## REVIEW OF ACCESSIBILITY MATTERS PILU RESTAURANT, 80 UNDERCLIFF ROAD, FRESHWATER NSW

City Plan Services has reviewed the access assessment review prepared by Jensen Hughes (JH) Reference 118680 Rev 1 dated 08 December 2023 against City Plans original Accessibility report Reference RE220634.02 dated 06 June 2023 and undertake further assessment of the site to ascertain appropriate level of access with reasonable recommendations.

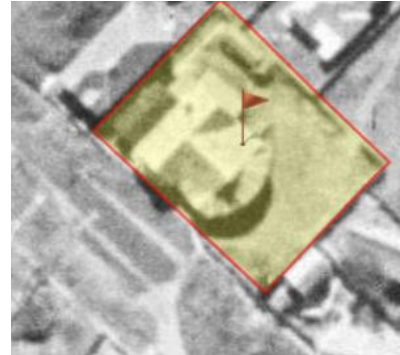
It is alternatively recommended that an accessway is provided from the Moore Road entrance which provides access to the wedding pavilion, the current main entrance and to an external platform lift. An unroofed low rise external platform lift could be provided to the eastern side of the restaurant and connected to a new principle pedestrian entrance to the Garden Room.

When compared to the Cityplan Proposal 2, the alternative recommendation outlined below would only include additional landscaping works to connect the lift to the Garden Room entrance doorway and this is readily achievable within the existing terraced seating area without substantial visual appearance due to the ability for unroofed platform lift to be concealed within existing landscaping.

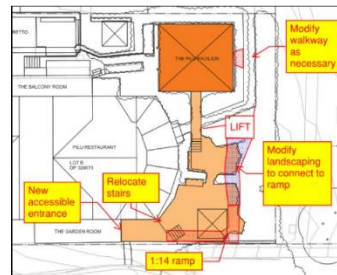
The works suggested by JH in their figure below is considered to be unreasonable, extremely cost prohibitive, and damaging to the building curtilage, biodiversity and physical built form/aspects of the existing development.

On the basis of a comprehensive reinspection and reassessment to ensure Council and public benefit is achieved. The following is proposed:

Provision of a compliant ramp/pathway (highlighted in green below), skirting a tree and TPZ adjacent to the existing Council walkway (highlighted in yellow below);

Provision of a splay for joint accessibility i.e. Council footpath and ramp way. (under Section 68 of the Local Government Act); and
